**Eugene School District 4J
ROOSEVELT MIDDLE SCHOOL**
680 East 24th Avenue
Eugene, OR 97405
CIP No. 410.566.001

ADDENDUM NO. 1

This Addendum forms a part of the Contract Documents and modifies the original Bidding Documents dated February 18, 2015 as noted below. Acknowledge receipt of this Addendum in the space provided on the Bid Form. Failure to do so may subject the Bidder to disqualification.

DETL/SHT: **D1/A-256**
 REF: **ADDENDUM 1**

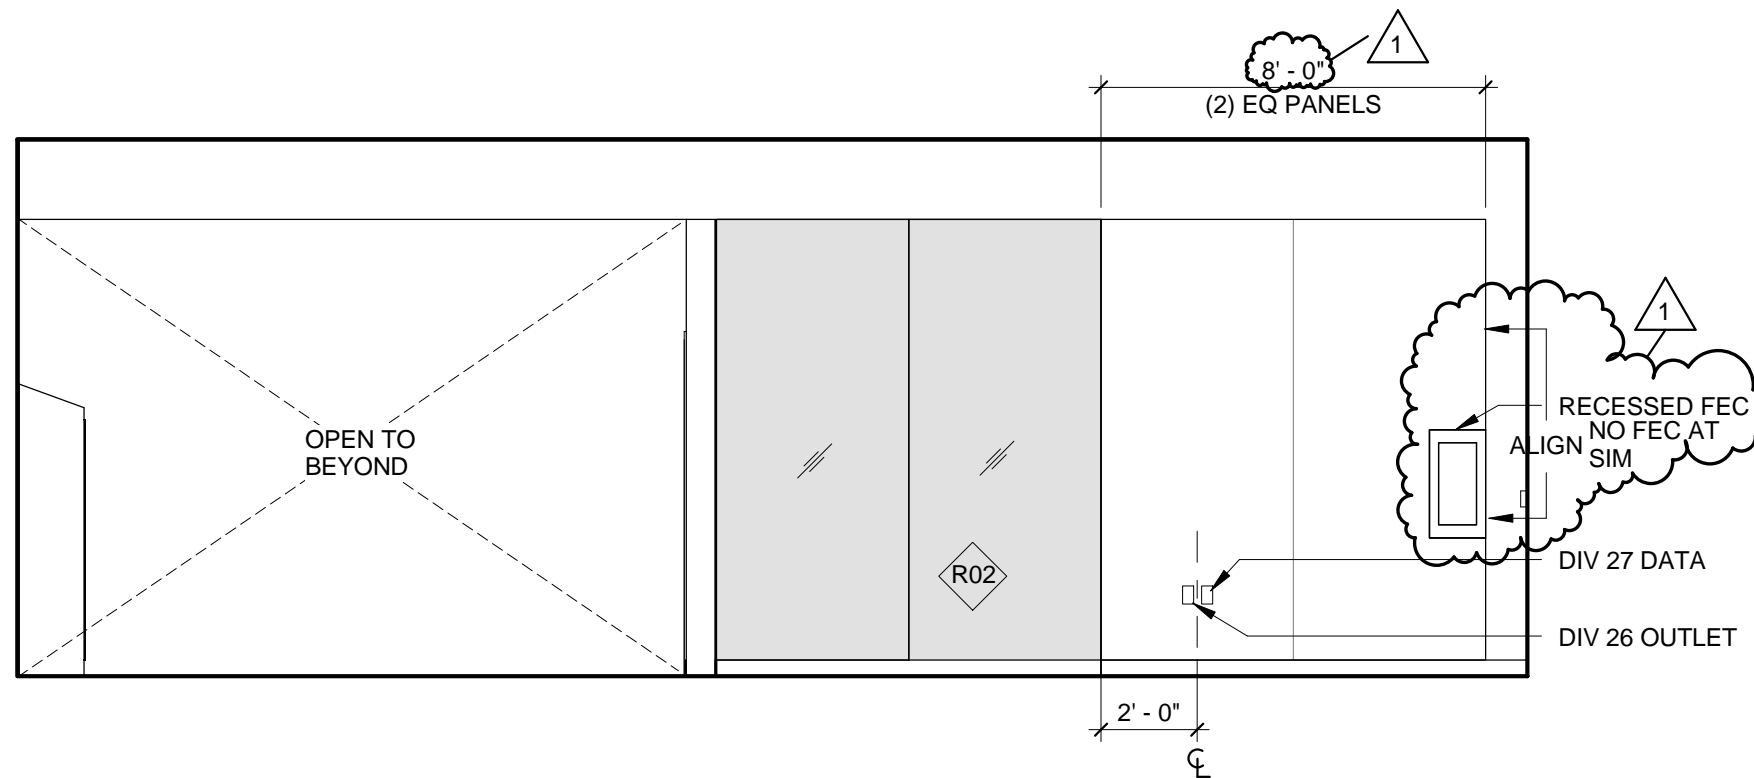
A. Detail D1/A-256: Revise as indicated in attached Drawing ASK-A-256-01.

DETL/SHT: **B1/A-270**
 REF: **ADDENDUM 1**

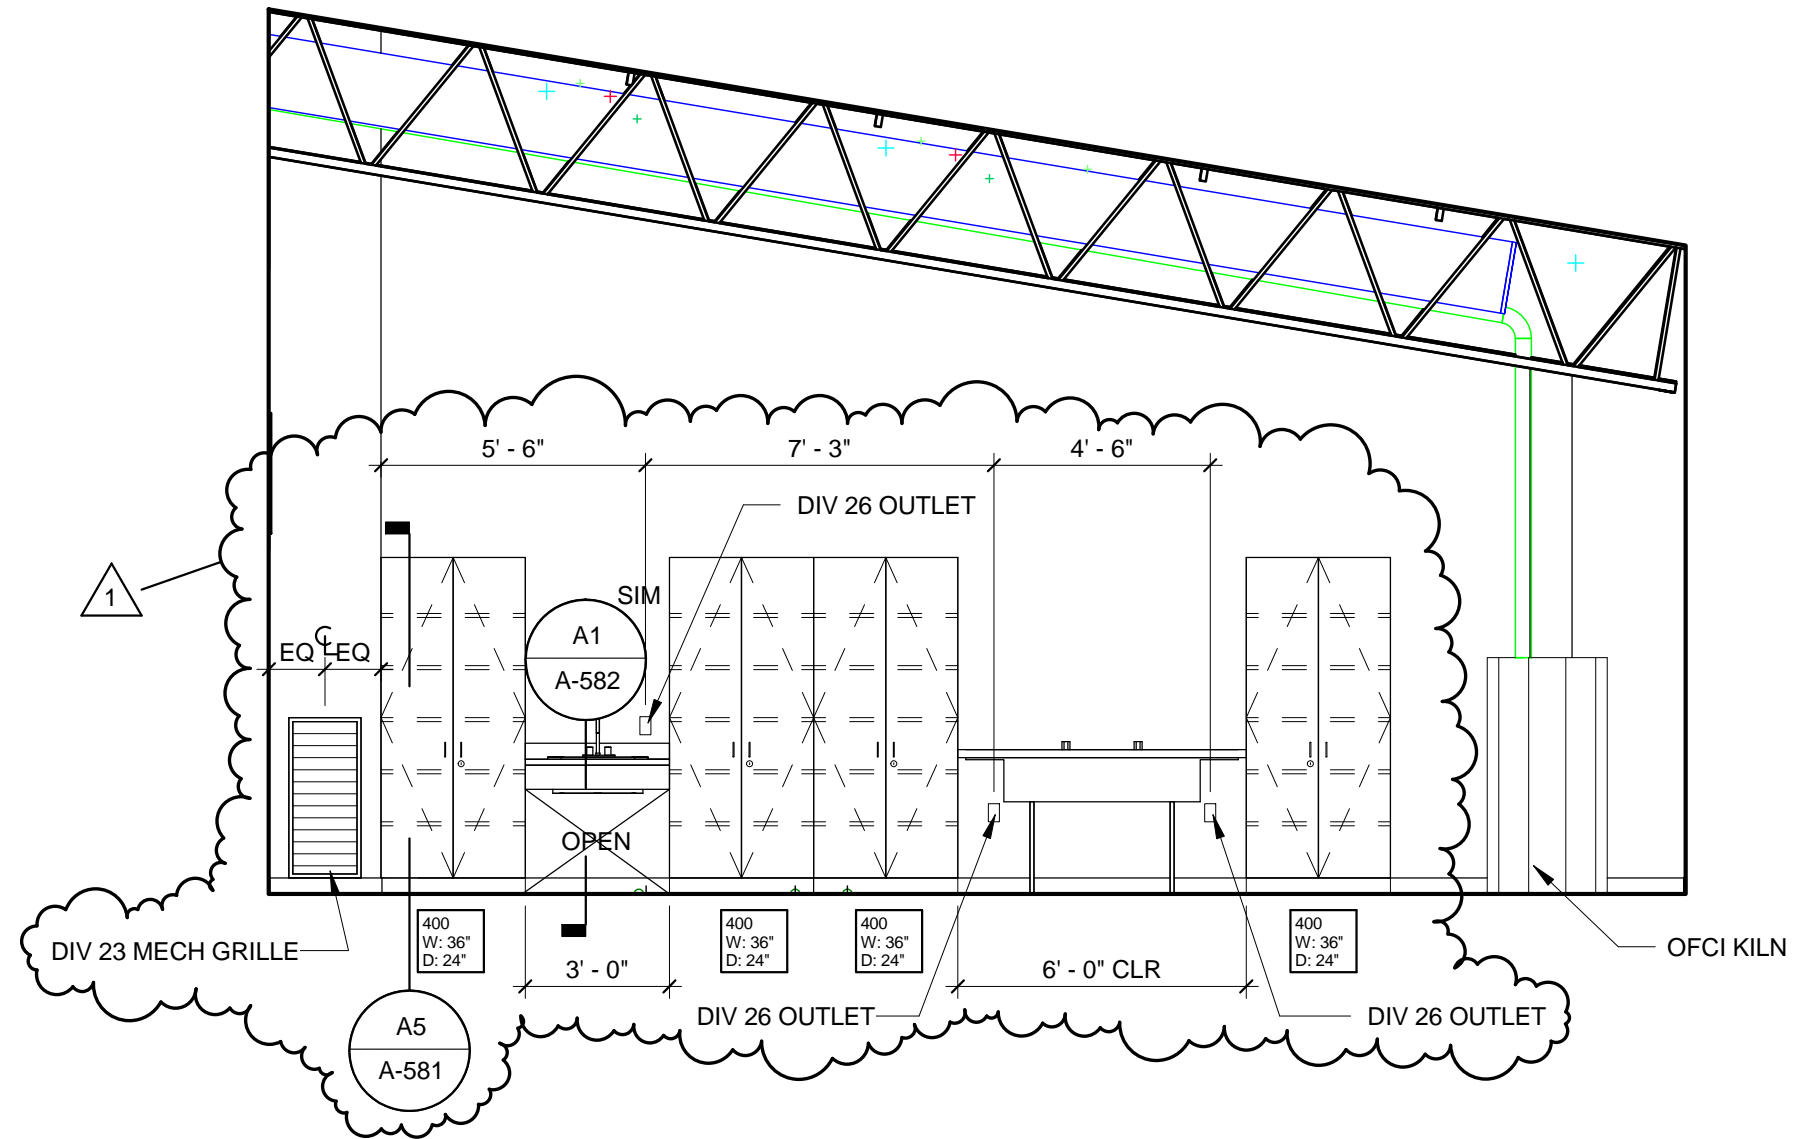
A. Detail B1/A-270: Revise cabinet layout as indicated in attached Drawing ASK-A-270-01.

A1 BASE CABINET AT SINK

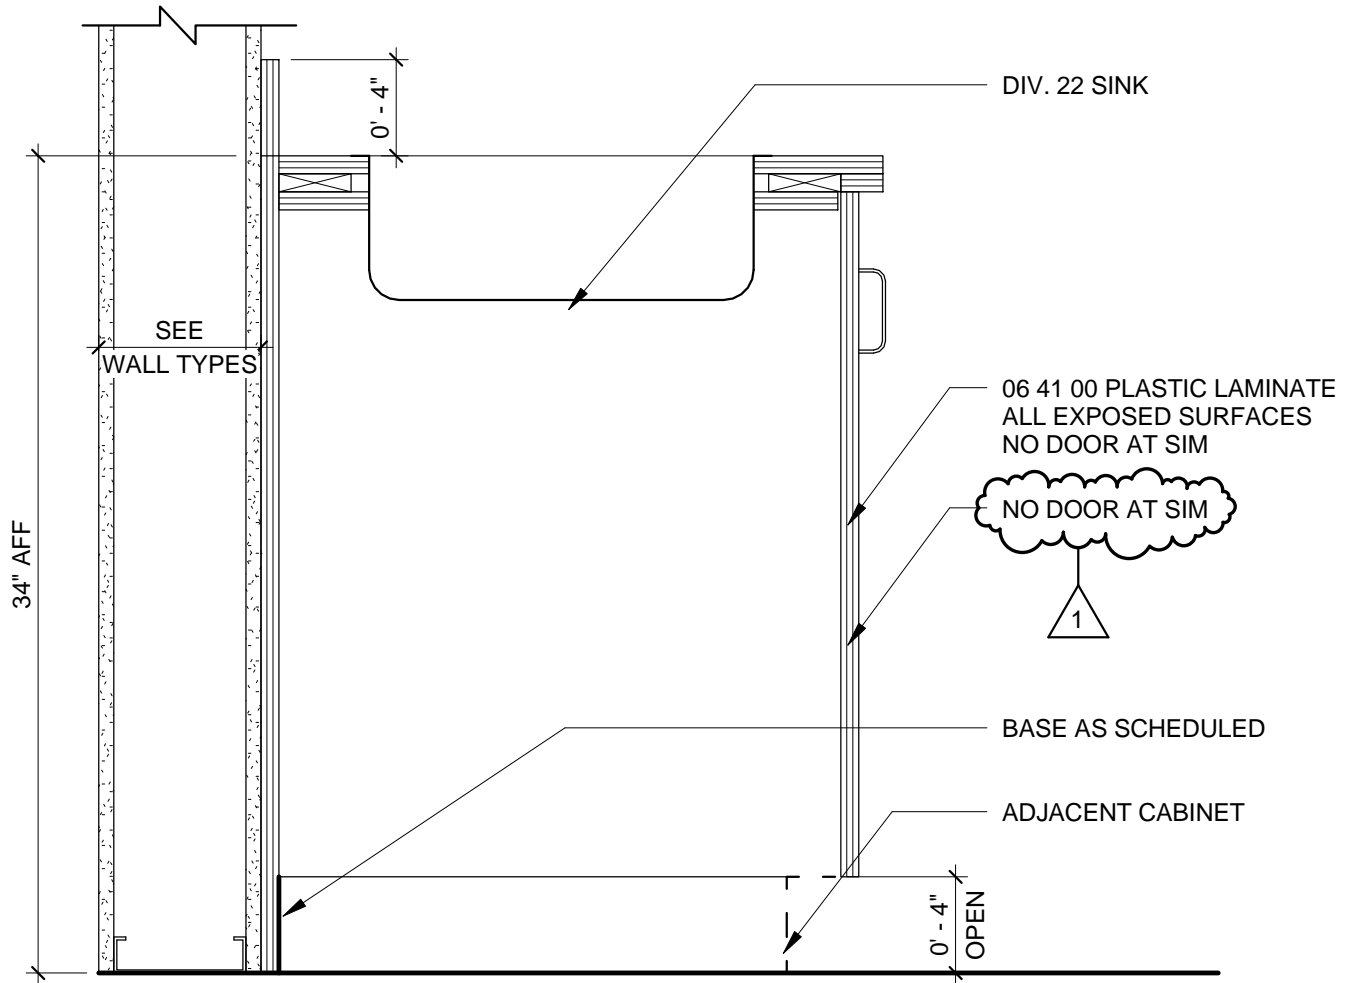
- A. Detail A1/A-582: Add note as indicated in attached Drawing ADD-A-582-01.

A1 MECHANICAL EQUIPMENT PLATFORM PLAN - ZONE A WEST- MECHANICAL
1/4" = 1'-0"

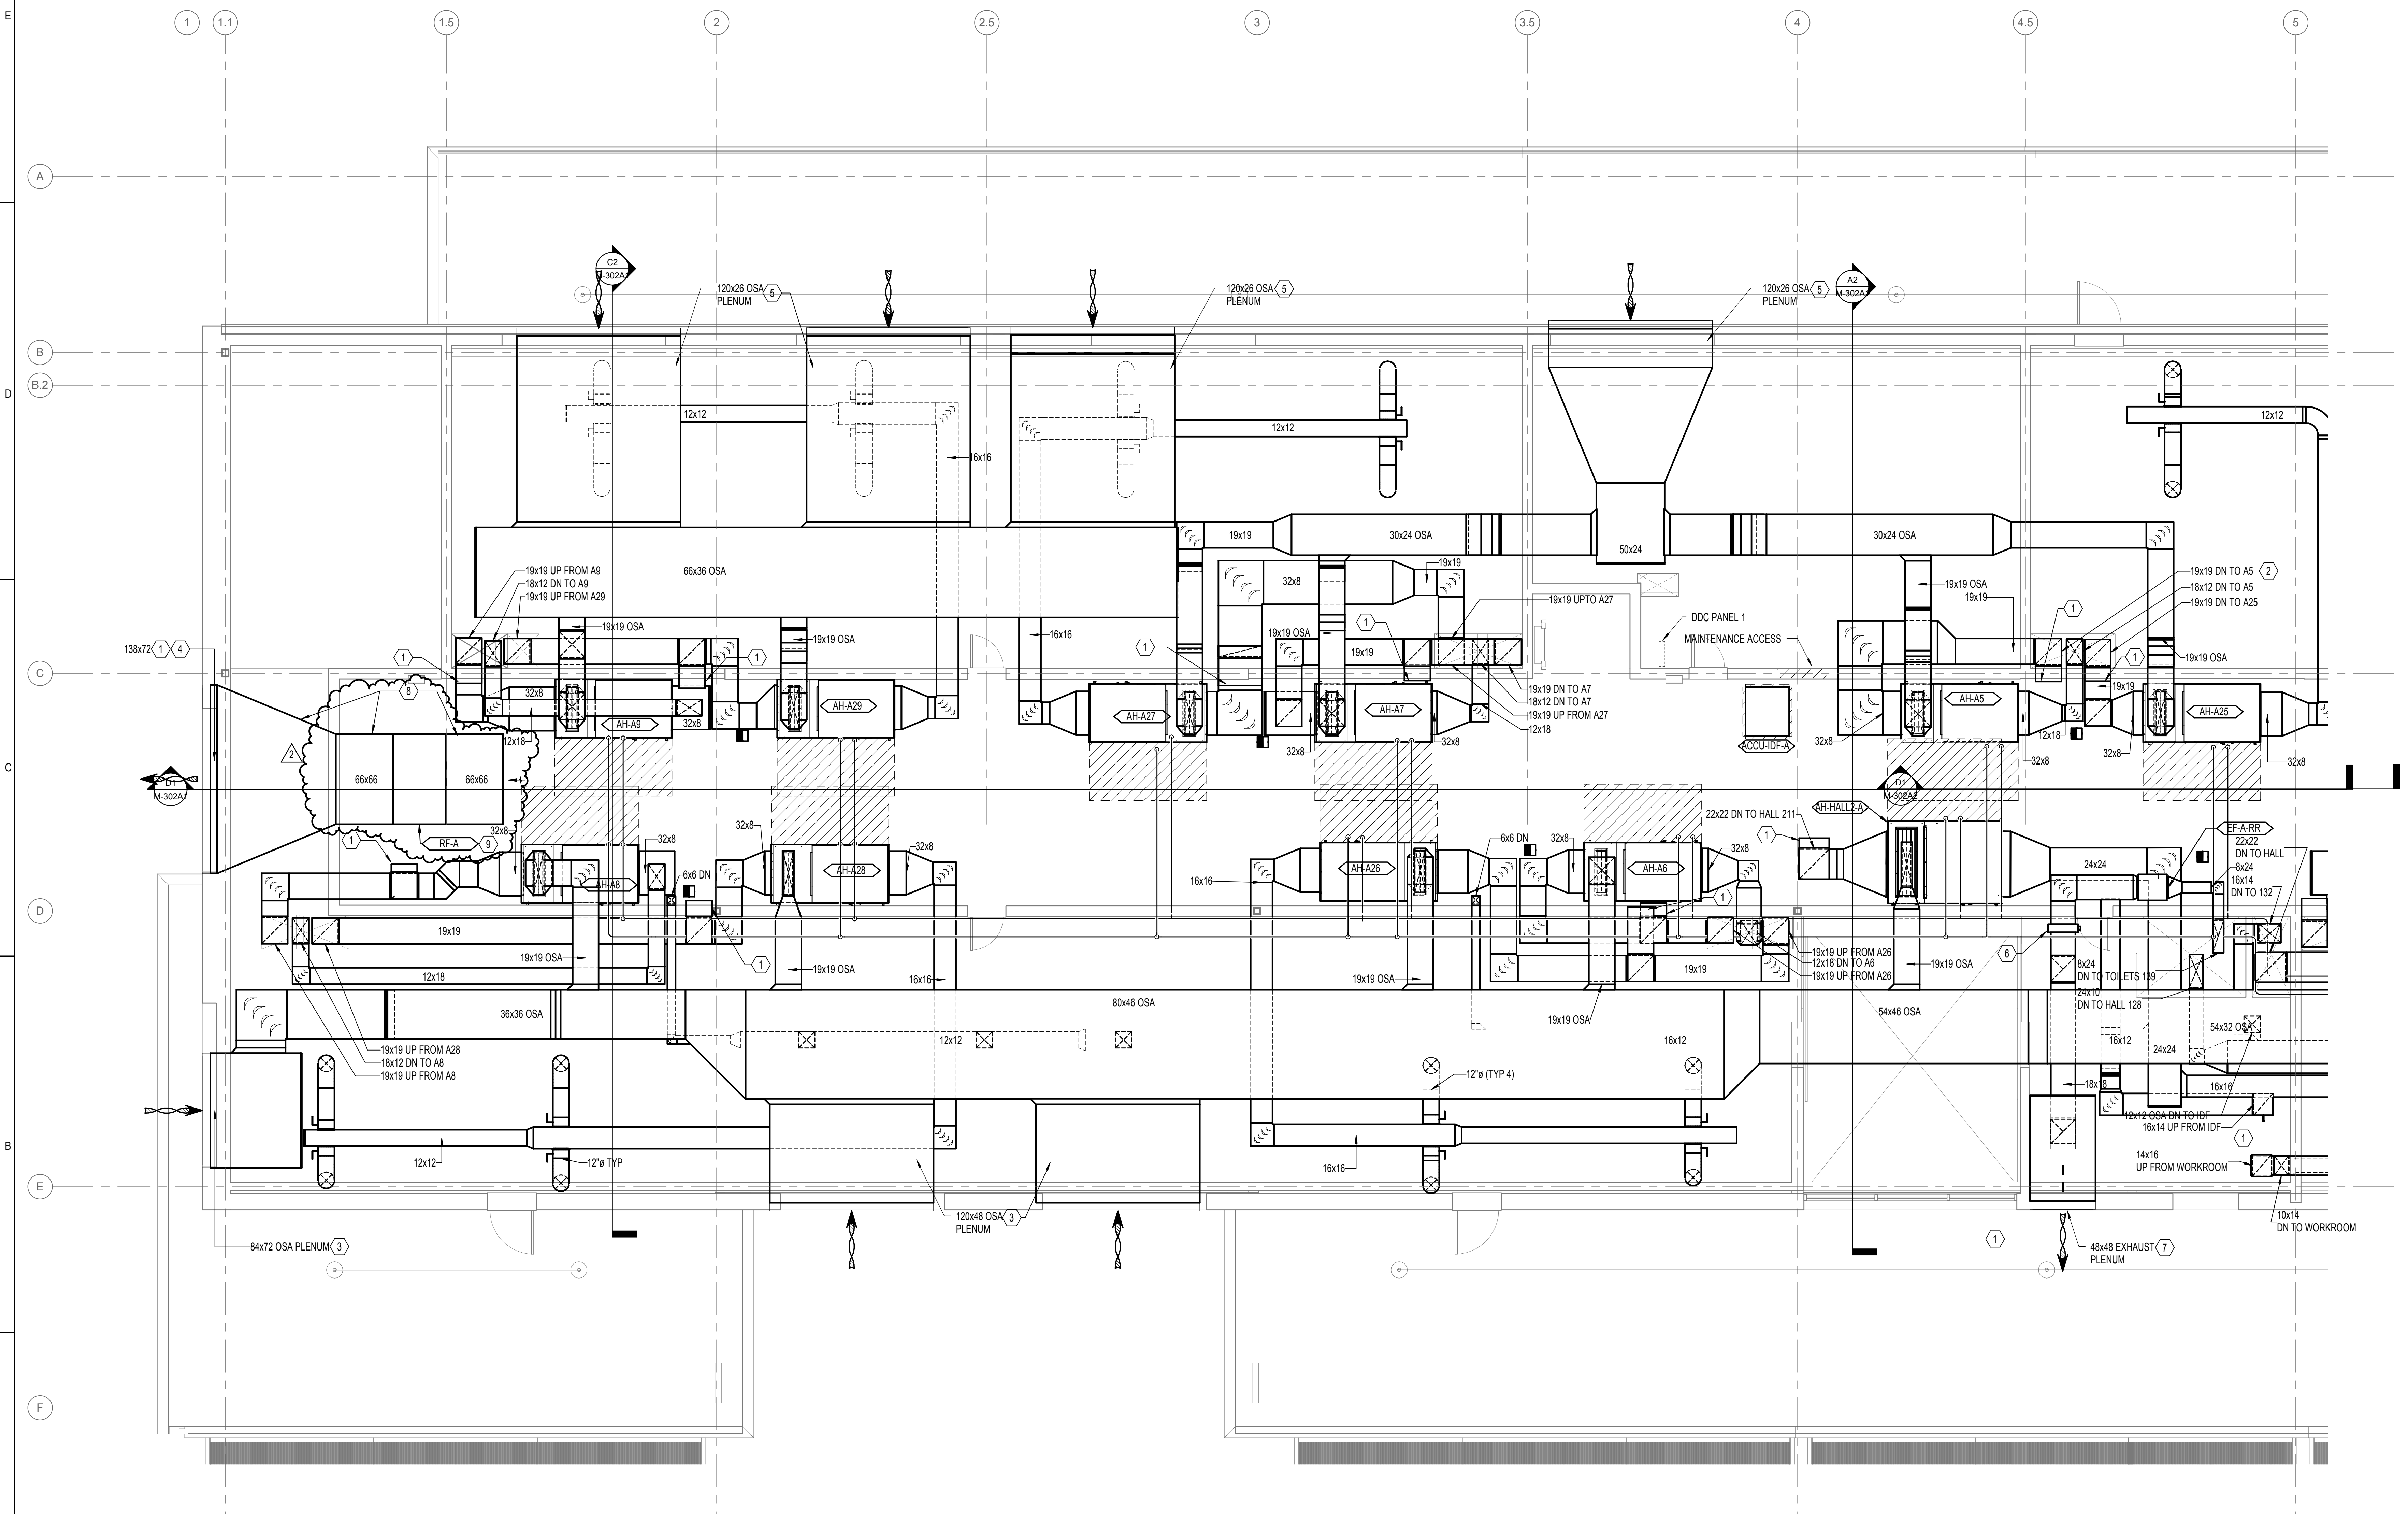
- A. Replace Sheet with attached new Sheet M-401A1. Clarification: Added note 8 and 9 for RF-A duct/plenum acoustical lining and fan ceiling mount/isolation.
